Re: S/D 89-39 - Sketch Plat of Lost Creek Estates Addition,
located east of 119th St. West between 13th St. North and
Central

Indicated below are comments concerning the above referenced
plat.

Re: S/D 89-39 - LOST CREEK ESTATES

Case No: 917032

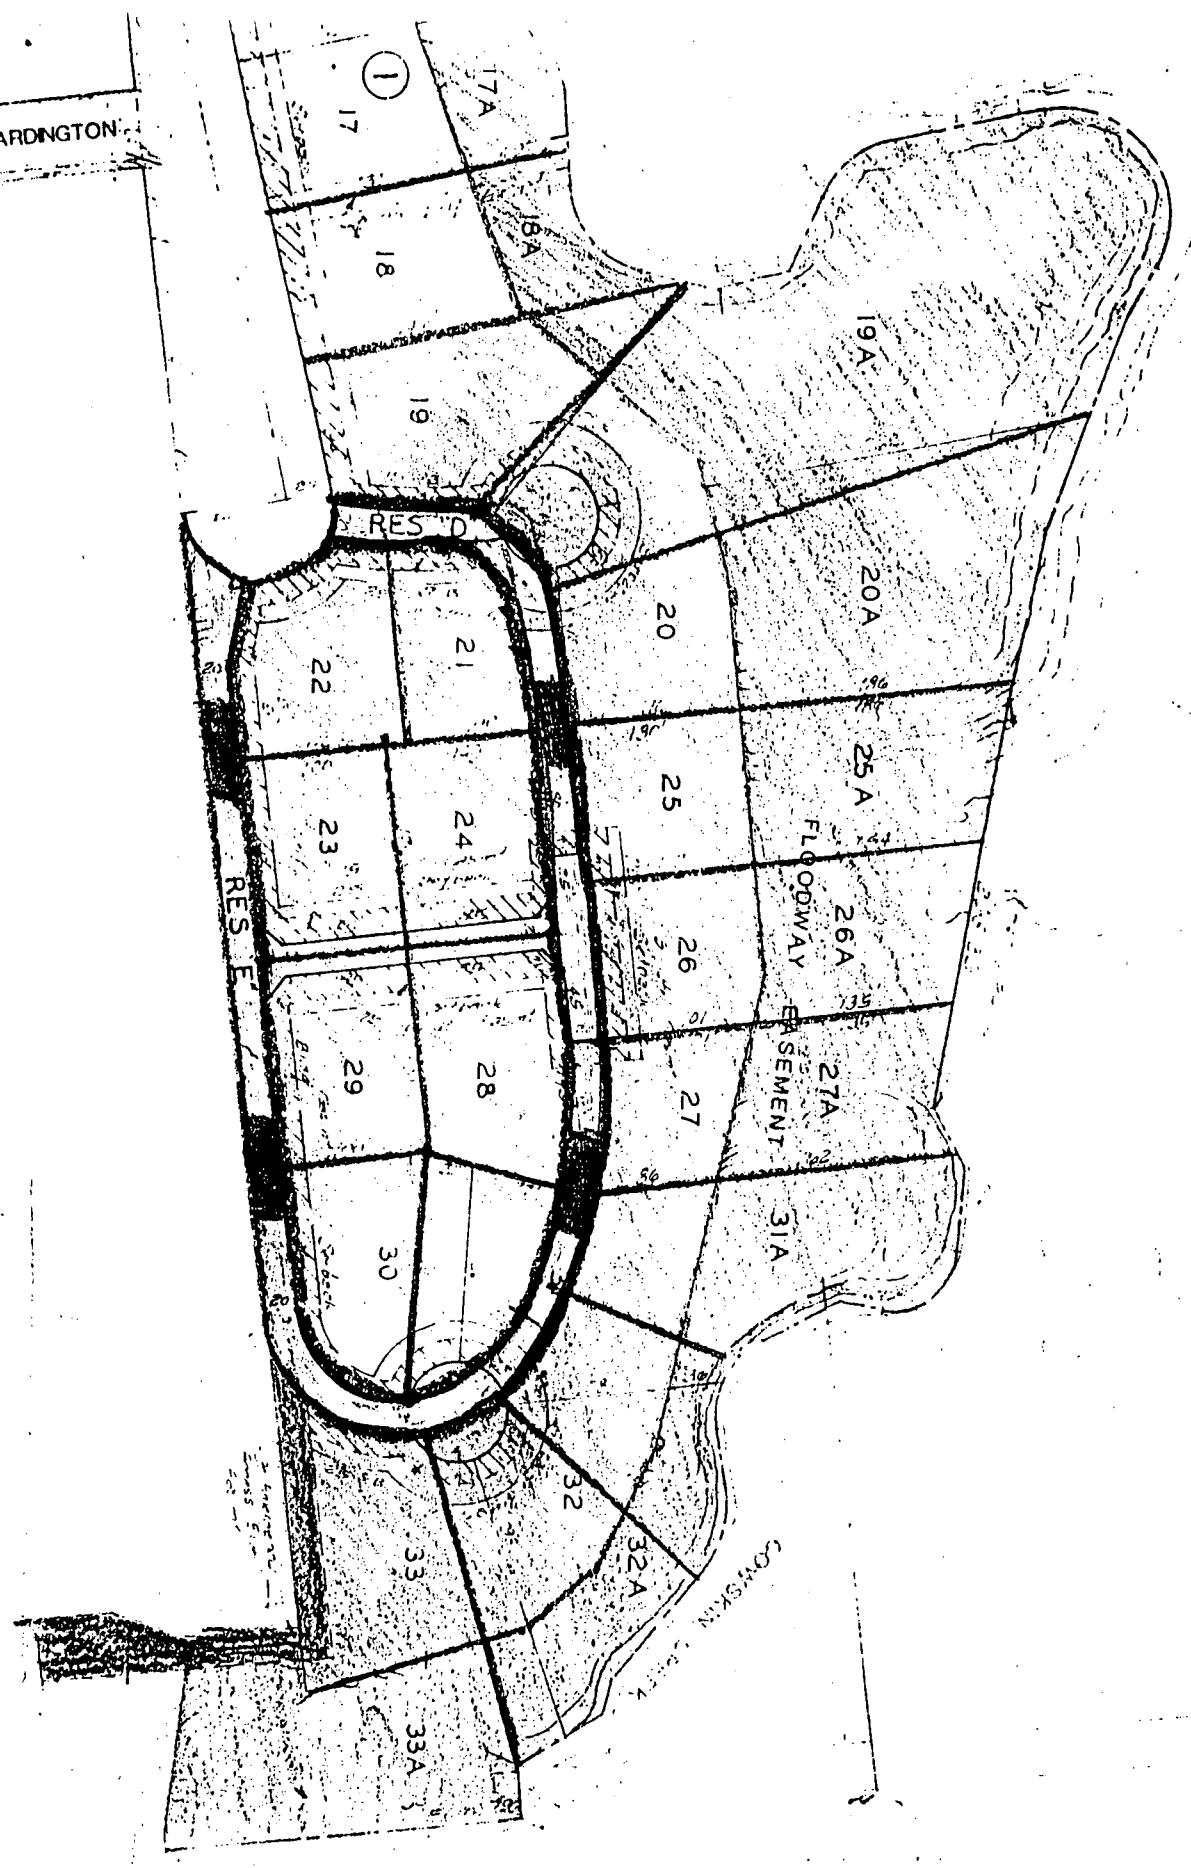
- A. We do not support the platting of long, cul-de-sac type streets with a 58-foot right-of-way. Although your plat shows a connection from Lost Creek Circle to Kenny, in the abutting Golden Hills 5th Addition, this is over 1/4 mile from this street's entrance at 119th Street West. A 64-foot right-of-way and associated paving width standard should be dedicated for this street.
- B. As indicated above, we will not support private streets for this site but we will support 32-foot right-of-way, with 29-feet of paving and adjacent 15-foot street-drainage-utility easements.

In reviewing the layout of the section of the plat involving private streets, we suggest that a looped type street pattern be considered rather than the three culs-de-sac shown. A looped street will significantly improve emergency access to this portion of the plat, and will eliminate the need for a 20-foot emergency access easement to the southeast. In addition, a looped street would appear to provide a more acceptable street layout and traffic circulation pattern. It appears that additional lots could be provided around such a street layout with only a marginal change in individual lot sizes shown on the sketch's proposal. We have attached a copy of how such a looped street could be incorporated into this site.

- C. The "A" lots would all appear to be in what should be platted as floodway. The lots in the eastern 1/3 of this plat also appear to be within the floodway. The City Engineer's Office should be contacted to confirm the boundary of the floodway needing to be reserved.

- D. The alignment of Lost Creek Circle as it swings south, to the south line of this plat, will create double frontage lots for properties in the Golden Hills 5th Addition. Those lots will have legal access to this new street unless complete access control is dedicated. You might want to consider shifting Lost Creek Circle northward somewhat and platting a Reserve for landscaping between this street and the properties to the south.

- E. The position of Reserve A, at the entrance to this site at Lost Creek Circle, should typically allow greater street width for exiting traffic. We assume that greater right-of-way and pavement should be provided to the north of this Reserve rather than south of it.

MAP ANNOTATED TO SHOW
CHANGES MADE EFFECTIVE
BY LETTER OF MAP REVISION
DATED: JAN 31 1992

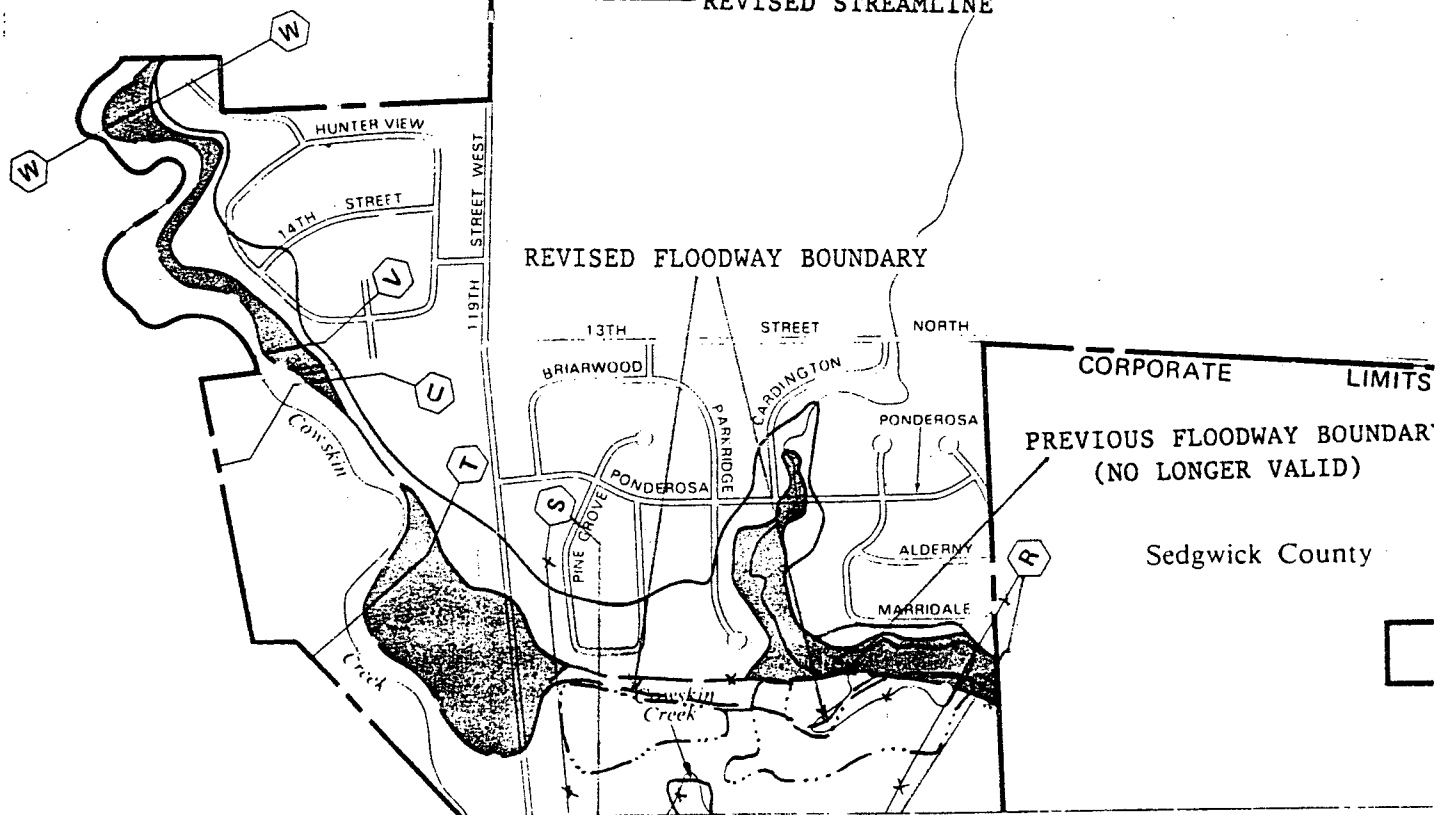
We have reviewed the information submitted by Mr. Wooten and agree that the Flood Boundary and Floodway Map (FBFM) for the City of Wichita should be revised. Based on the channel modifications, new pedestrian bridge, and updated topographic data, the floodway has been narrowed by as much as 300 feet at a point about 0.64 mile downstream of 119th Street West. The floodway has also been widened by about 150 feet at a point about 0.56 mile downstream of 119th Street West. In this area, the floodway boundary is coincident with a pond shoreline and will not affect any property owners. The revised floodway is shown on the enclosed annotated copies of FBFM Panels 0005 and 0020 and the Floodway Data Table.

This Letter of Map Revision (LOMR) officially revises the effective FBFM Panels 0005 and 0020, dated May 15, 1986. The revised floodway is effective as of the date of this letter. Any requests for further modifications to the community's FBFM, or for reconsideration of this LOMR, must be based on scientific or technical data.
